## Department of Transportation

#### MEMORANDUM

**SUBJECT:** BZA Case No. 20082 – 2721-2725 Martin Luther King Jr Avenue SE (Southeast Academy)

Figure 4. Pick-up and Drop-off Circulation (Source: Applicant’s CTR, Figure 6)

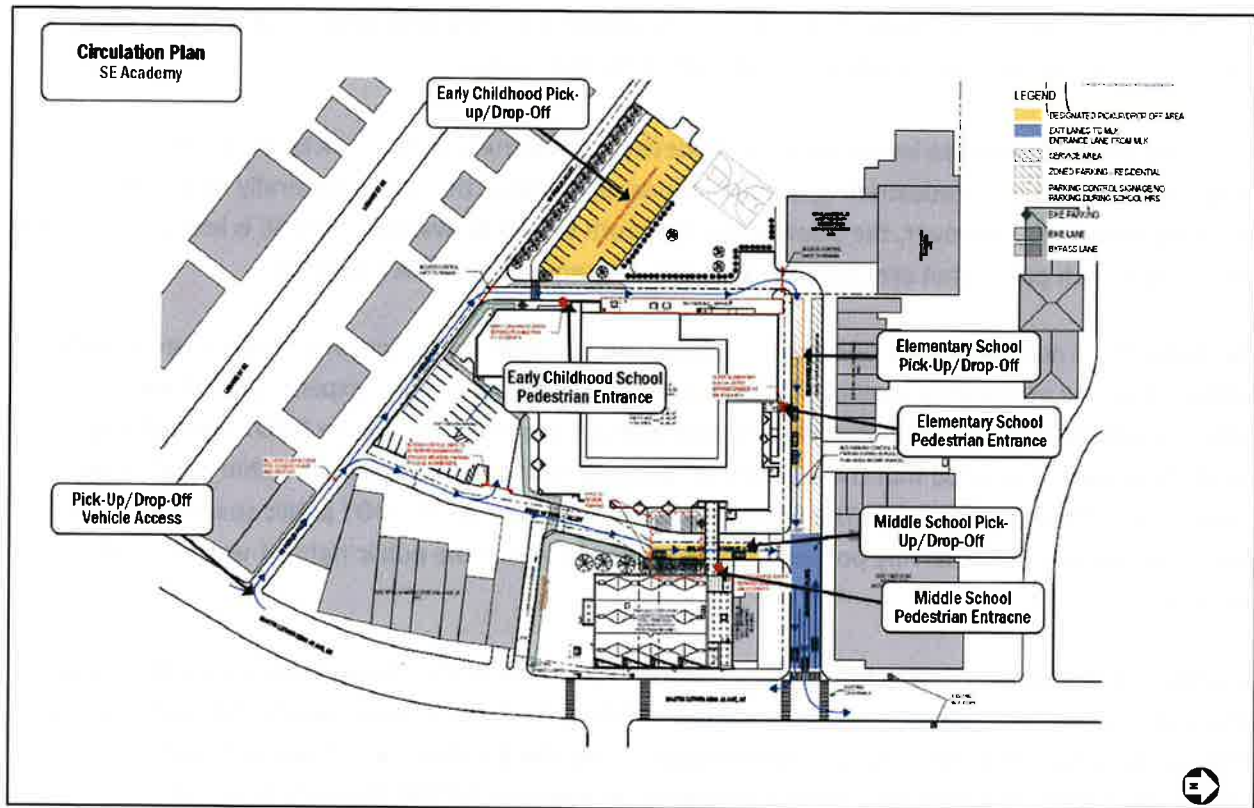
Pick-up/drop-off points are proposed through the alley network and along Milwaukee Place SE. All vehicles will enter through the alley and exit via Milwaukee Place SE to Martin Luther King Jr Avenue SE. The Early Childhood vehicles will utilize the western parking lot to walk in young children, the elementary school students will be picked-up and dropped-off on Milwaukee Place SE, and the Middle School students will be picked-up and dropped-off along the north/south public alley. The Applicant coordinated with DDOT to propose circulation plans for both school buildings to maximize available queue space and provide optionality for vehicles accessing the site in a manner that effectively distributes site traffic to minimize impacts.

The Applicant prepared analysis that shows queues for both these locations should be contained on-site, with no backing up into public space anticipated. DDOT notes that this is critical, as queuing into public space or onto adjacent public streets is unacceptable. The proposed operations plan is described below.
